SUNDRY NOTICES AND REPORTS ON WELLS
Do not use this form for proposals to drill or to re-enter an abandoned well. Use Form 3160-3 (APD) for such proposals.

8. Well Name and No.
McClellan Federal #1

9. API Well No.
30-005-63076

McClellan Federal 1
30-005-63076
Primerio Operating, Inc.
August 26, 2019
Conditions of Approval

PROPOSED PLUGS

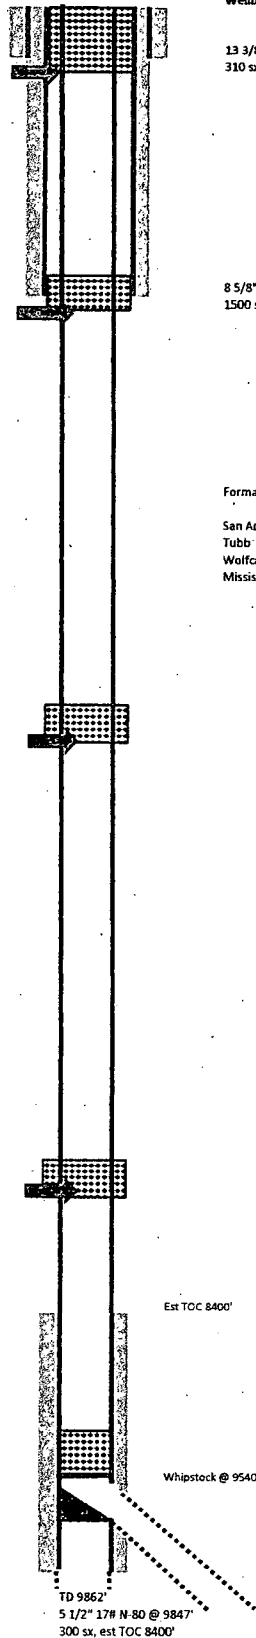
Plug 5: 100 sx C
Surface to 350'
Perforate 350'

Plug 4: 40 sx @ 5195'
5095 to 5195'
Perforate 5195'

Plug 3: 40 sx Class C @ 5195'
5095-5195'
Perforate 5195'

Plug 2: 40 sx Class H @ 7130'
7030 to 7100'
Perforate 7130'

Plug 1: 40 sx Class H @ 9500'
9050-9160
CIBP @ 9500'

1. Operator shall place CIBP at 9,500' and place 40 sxs of Class H cement on top as proposed. WOC and TAG.
2. Operator shall perf and squeeze at 7,130'. Operator shall place a balanced Class C cement plug from 7,130'-6,960' to seal the top of the Wolfcamp formation. WOC and TAG.

3. Operator shall perf and squeeze at 6,036. Operator shall place a balanced Class C cement plug from 6,036'-5,876' to seal the top of the Abo formation. WOC and TAG.

4. Operator shall perf and squeeze as proposed at 3,784'. Operator shall place a balanced Class C cement plug from 3,784'-3,644' to seal the Glorietta Formation. WOC and TAG.

5. Operator shall perf and squeeze as proposed at 2,378'. Operator shall place a balanced Class C cement plug from 2,378'-2,278' to seal the 8-5/8" casing shoe. WOC and TAG.

6. Operator shall perf and squeeze at 1,050'. Operator shall place a balanced Class C cement plug from 1,050'-850' to seal the top of the Yates and bottom of the Salt formation. WOC and TAG.

7. Operator shall perf and squeeze at 500'. Operator shall place a balanced Class C cement plug from 500'-254' to seal the top of the Salt formation and the 13-3/8" casing shoe. WOC and TAG.

8. Operator shall perf and squeeze as proposed at 100'. Operator shall place a balanced Class C cement plug from 100'-surface as proposed.
9. See Attached for general plugging stipulations.
